ADDENDUM NO. 2

VILLAGE OF COVINGTON Wastewater Treatment Plant Improvements Phase II Blower Replacement February 19, 2019

Re: Village of Covington
Wastewater Treatment Plant Improvements Phase II – Blower Replacement

PROJ. NO: CV07112617	DWG. NO: 1D15072	SCALE: AS NOTED
DRAWN: DRM	CHECKED: MJB	DATE: 02/15/19 SHEET NO: 6A OF 9

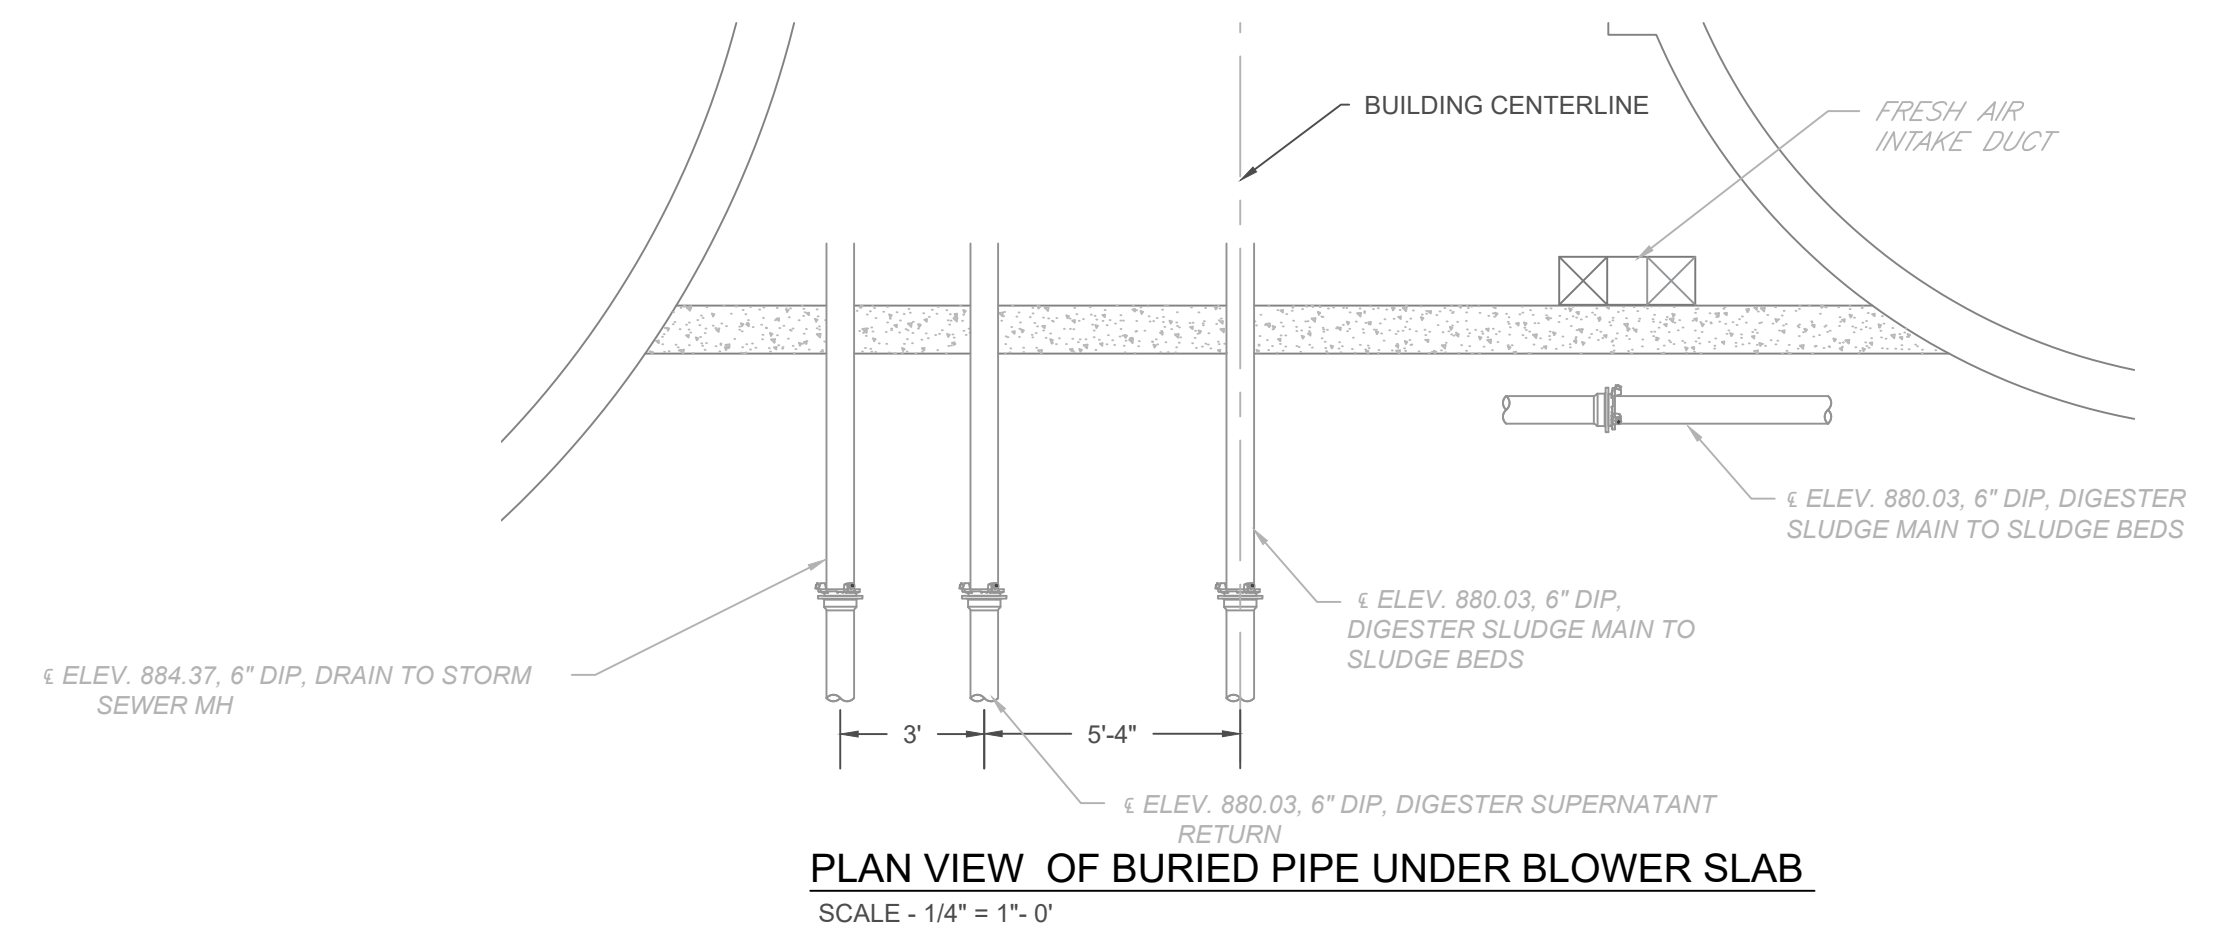
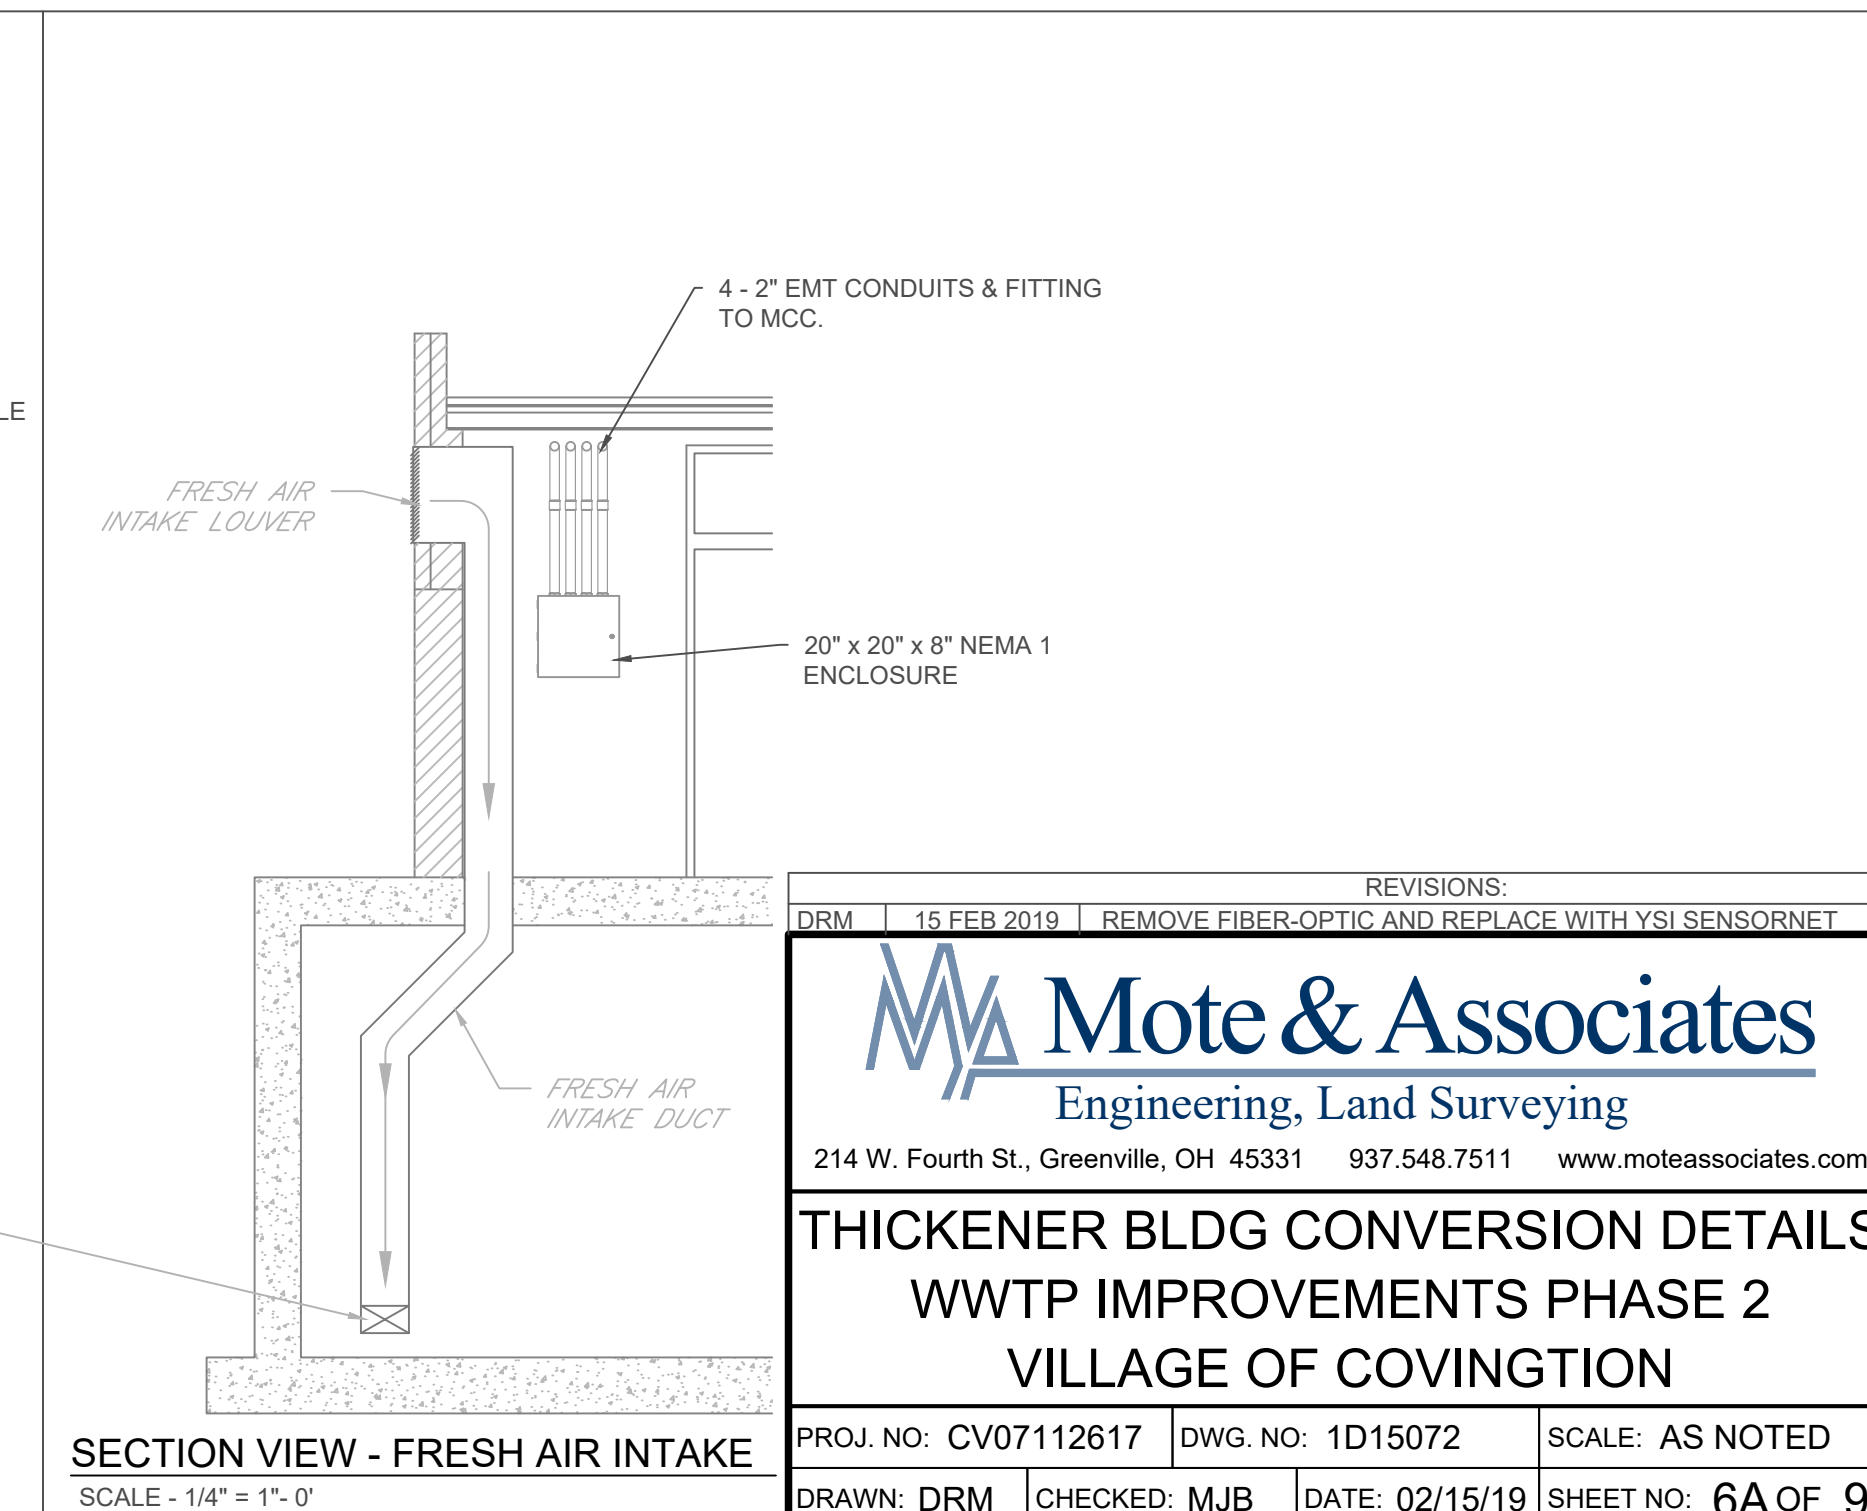
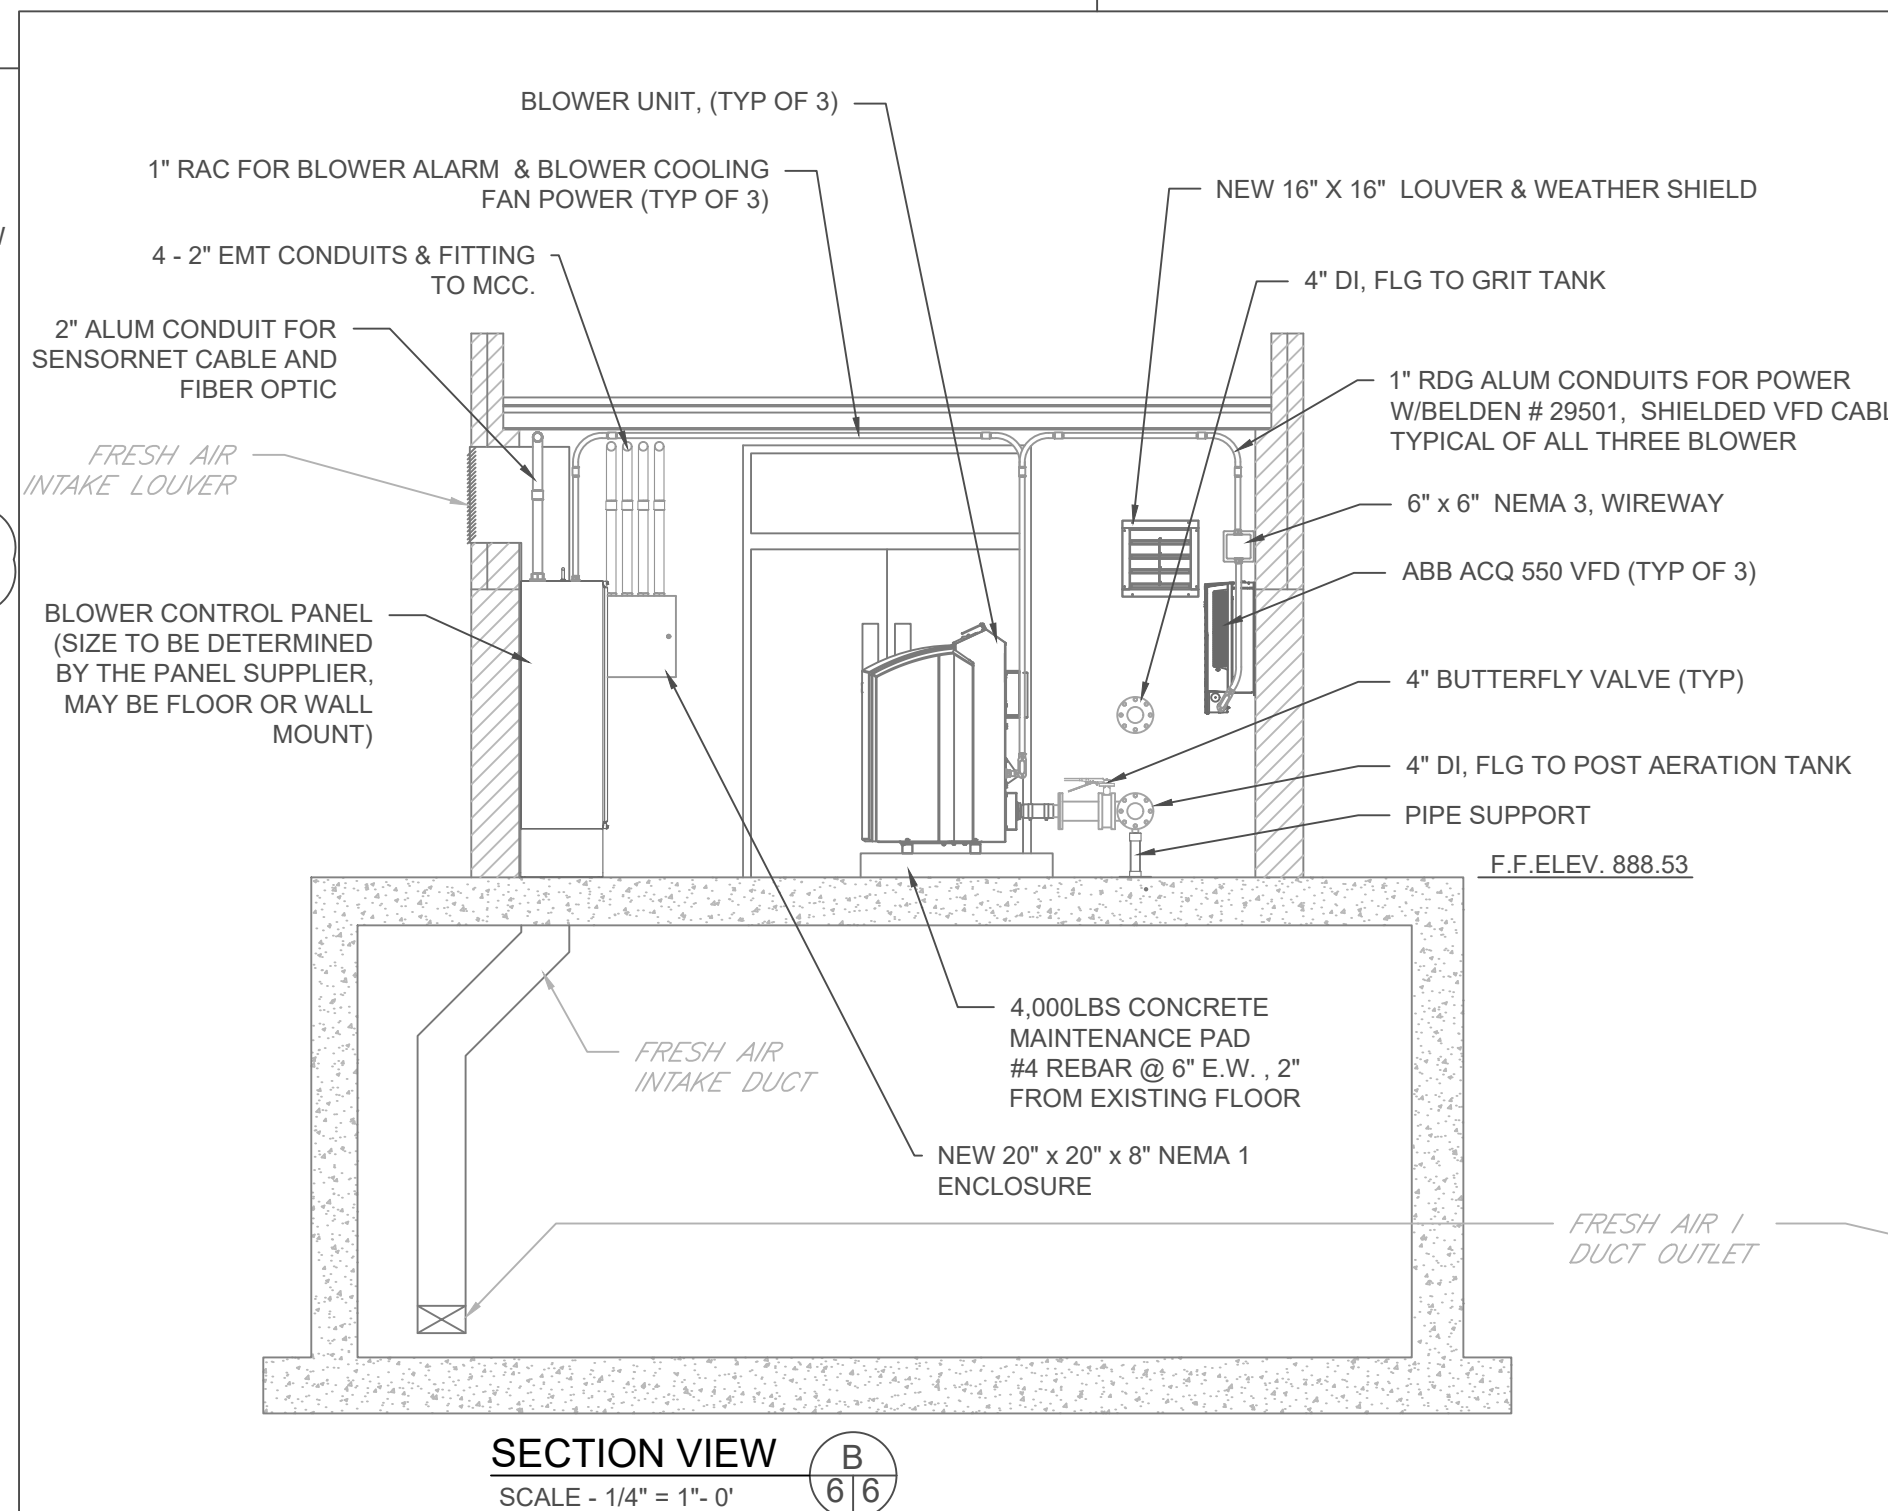
3. Sheet 2A has been updated indicated the amount of air piping to be replaced.
4. Sheets 3A, 4A, 6A, 8A and 9A indicate the changes from fiber-optic to SensorNet Cables.
5. Sheet 5A clarifies the water piping and obsolete equipment to be removed.

DRM	15 FEB 2019	REMOVE FIBER-OPTIC AND REPLACE WITH YSI SENSORNET
-----	-------------	---
